FIELD OBSERVATION – THIRD FLOOR IN-WALL AND CEILING ELECTRICAL REPORT 07-25-2016

AEI Project Number and Name: 14018 – The Park Danforth

Stair A

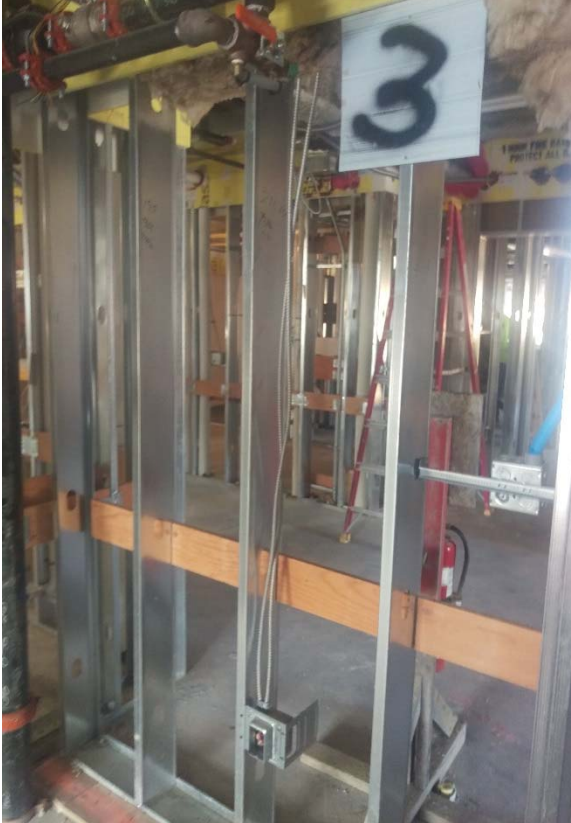
1. MC cable is not properly secured at third floor landing receptacle.
